Product Change Notification

1. ECN #: 297949

- CAT - CAT TOOLING

- CAT-EX-MPSS-01

New vs. Old Design

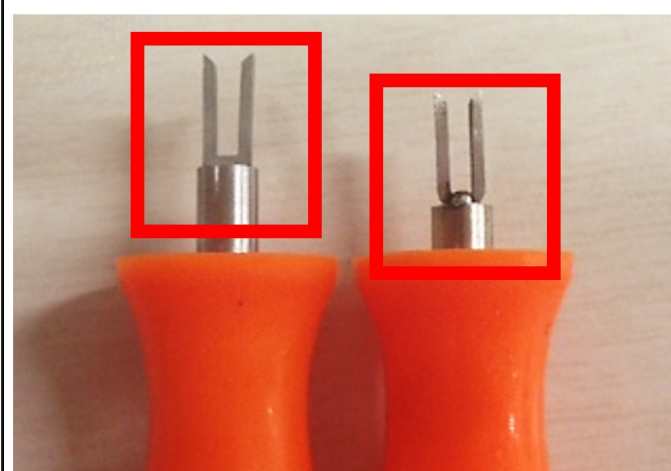
The core has been changed to a 1-piece design and the length of the core has been increased.

Measure overall length: 2.5" is the new length, 2.4" is the old length. Visually examine for the new solid 1-piece design instead of the old 2-piece soldered design.

- Form - Overall length has changed from 2.4" to 2.5", and the 2-piece soldered core has been switched to a 1-piece solid design.

Improving strength by changing the core to a solid 1-piece design as well as extending the core to aid in the extraction of edge positions.
